## 2.0 SITE CHARACTERISTICS

### 2.5.2 Vibratory Ground Motion

#### 2.5.2.1 Introduction

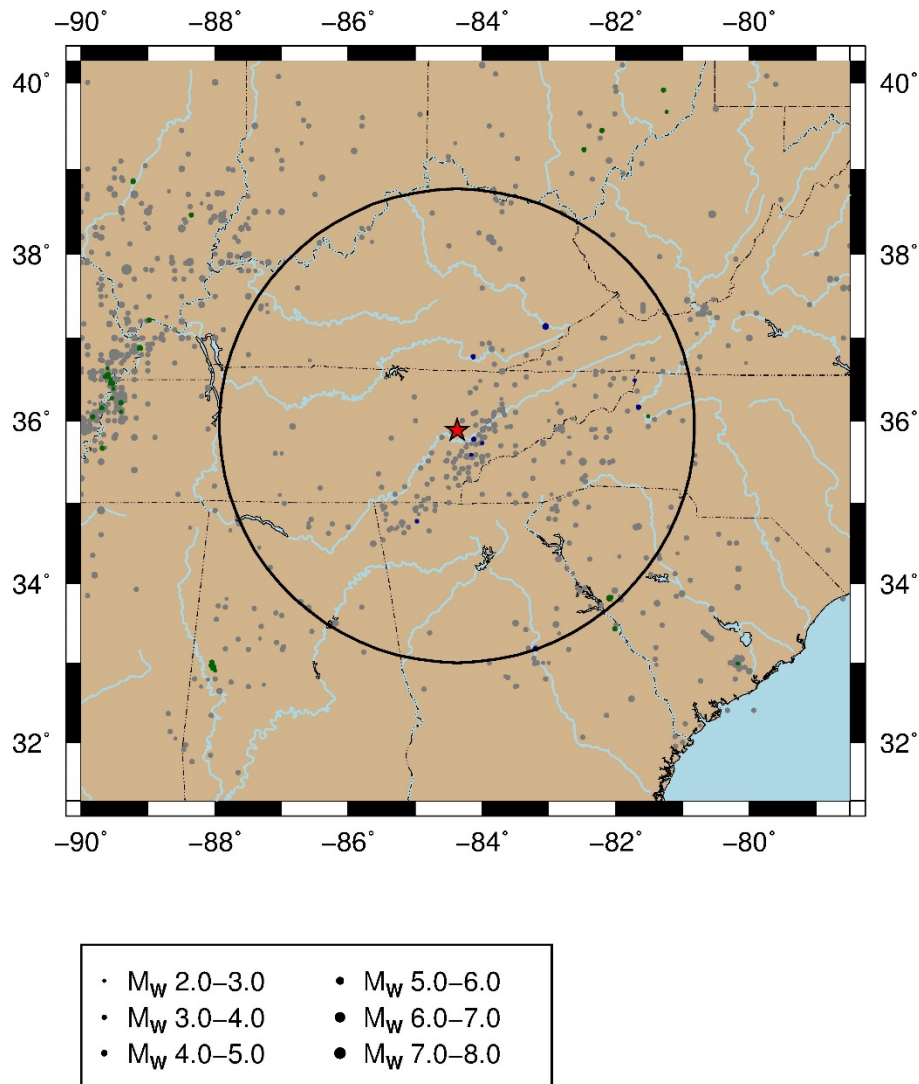
As part of its confirmatory analysis, the staff developed a supplementary earthquake catalog covering the CEUS region from 2013 through July 30, 2017. The staff used the USGS National Earthquake Information Center<sup>1</sup> earthquake catalog for this analysis. The staff reviewed its confirmatory catalog to determine whether there are new earthquakes in the CEUS region since the submission of the CRN Site ESP application that might impact either the  $M_{\max}$  of the seismic sources identified in the CEUS-SSC model or the earthquake recurrence rates calculated for each of the CEUS-SSC seismic sources used for the CRN Site PSHA. The staff searched for earthquakes in its confirmatory catalog with magnitude 2.9 and above within the time window from October 2013 through July 30, 2017, and within 500 km of the CRN Site. Figure 2.5.2-6 of this report shows the results of the staff's earthquake search. As shown in Figure 2.5.2-6, there are no recent significant earthquakes within 500 km of the site nor are there any new clusters of seismic activity not captured by the CEUS-SSC model. In particular, the staff's catalog showed that there were 31 earthquakes that occurred between October 2013 and July 30, 2017. None of these earthquakes have magnitudes greater than  $M5.0$  and the majority of the earthquakes identified by the staff in its supplementary catalog are small ( $M < 4.0$ ). Therefore, the staff

concludes from its confirmatory analysis that the earthquakes in the staff's supplementary catalog support the information used in the applicant's catalog for its PSHA.

**Figure 2.5.2-7: Comparison of applicant's base rock hazard curves with the staff's confirmatory hazard curves for the CRN Site**

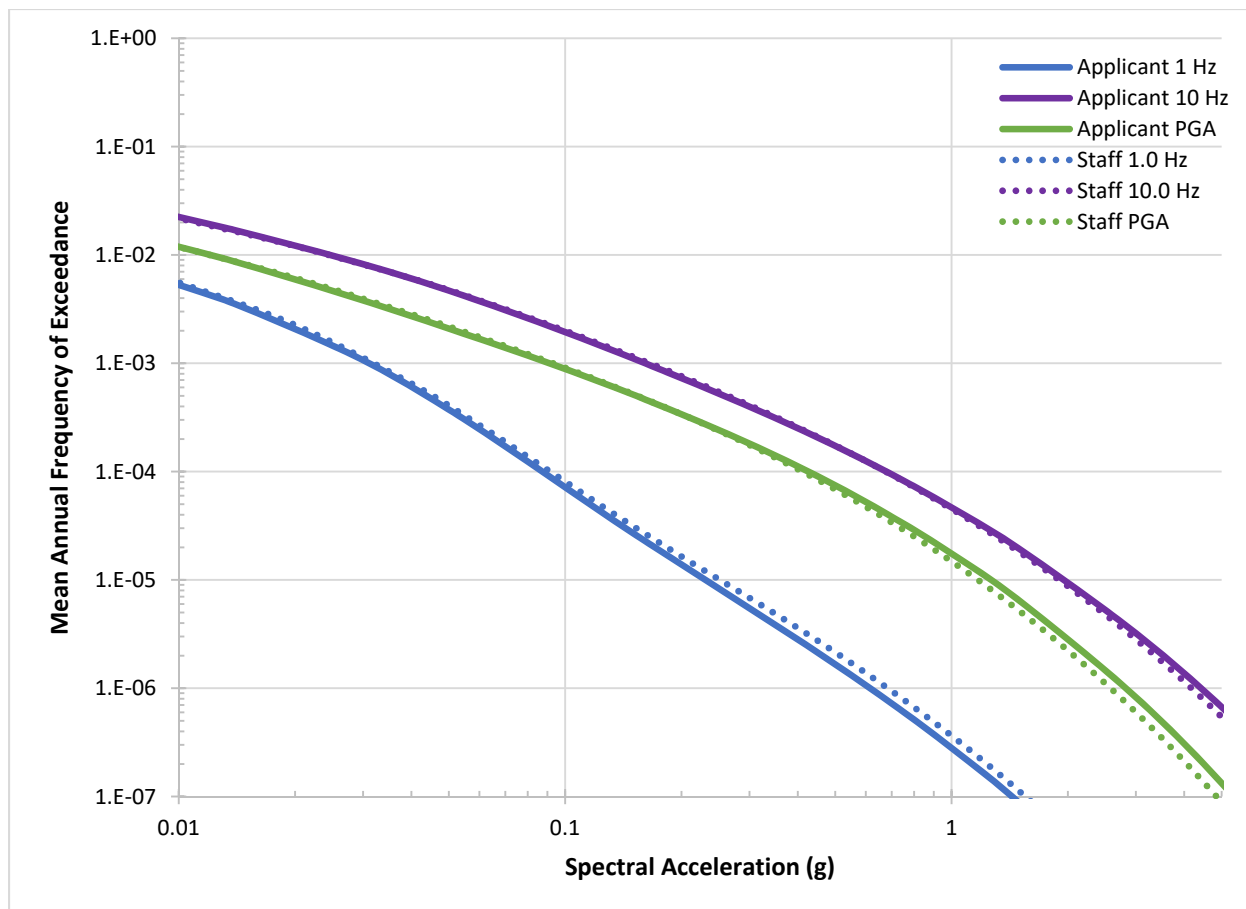
As part of its confirmatory analysis, the staff used the CEUS-SSC model background (distributed seismicity) sources and independently calculated the seismic hazard curves at the CRN Site for all seven ground motion frequencies defined in the EPRI (2013) GMPEs. The staff's confirmatory calculations also included RLME sources. From the CEUS-SSC model, the staff first selected all background seismic sources that are within 640 km (400 mi) of the site, which is consistent with the applicant's approach. Also consistent with the approach taken by the applicant, the staff included all RLME sources within 1000 km (620 mi) of the site. For its confirmatory PSHA, the staff used the original seismicity rates specified in the CEUS-SSC model rather than the updated rates used by the applicant. Figure 2.5.2-7 of this report shows the staff's results compared to those of the applicant for PGA and ground motion frequencies of 10 and 1 Hz. The staff confirmatory calculations show that for the annual exceedance frequencies of  $10^{-4}$ ,  $10^{-5}$ , and  $10^{-6}$ , the staff's seismic hazard curves are in good agreement with the applicant's seismic hazard curves. As such, the staff concludes that the applicant's update of the seismicity rates for the CEUS-SSC sources does not have a significant impact on the final base rock hazard results. Based on its confirmatory analysis, the staff concludes that the applicant adequately characterized the mean seismic hazard at the CRN Site.

**Figure 2.5.2-8: Comparison of applicant's (blue) and the staff's confirmatory GMRS (red) for the CRN Site. The generic hard rock ( $V_s=2.8$  km/s (9,200 fps)) GMRS (black dotted) is shown for comparison**

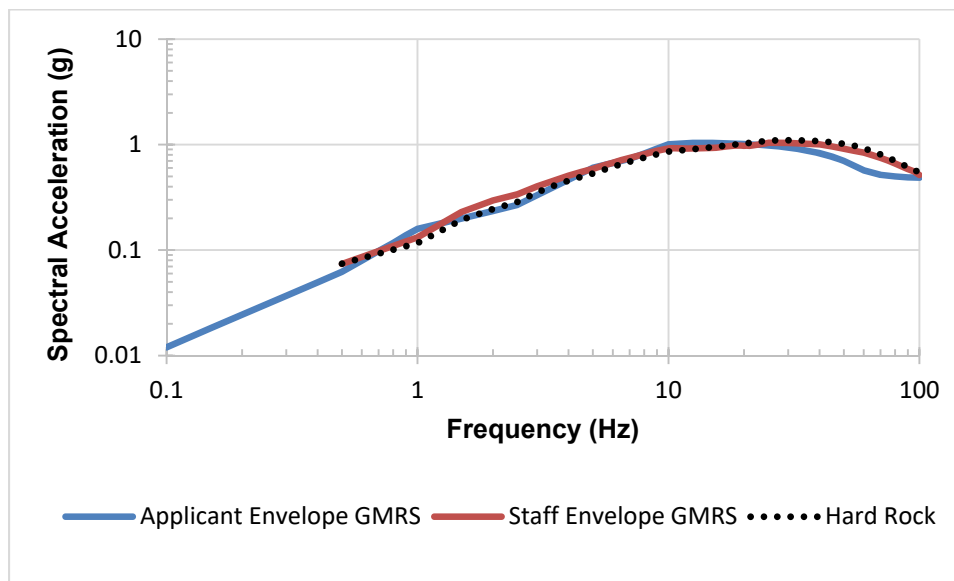
The staff's site-specific GMRS is compared to the applicant's in Figure 2.5.2-8 of this report. Given the high seismic velocities and relatively low impedance contrasts at the site, the staff considered a bounding analysis using a generic hard rock velocity of 2.8 km/s (9,200 fps). As shown in Figure 2.5.2-8, the applicant's and the staff's GMRS are consistent, demonstrating that amplification factors determined by the staff and the applicant are consistent even when considering differences in site response inputs and methodology. In addition, a GMRS calculated using generic hard rock conditions is consistent with both the applicant's and the staff's GMRS developed using site-specific information. This comparison further demonstrates the relative insensitivity of the site to site response inputs due to high seismic velocities and low impedance contrast between layers in the subsurface. Based on the above assessment, the staff concludes that the applicant's site response calculations adequately characterize the site effects at the CRN Site.
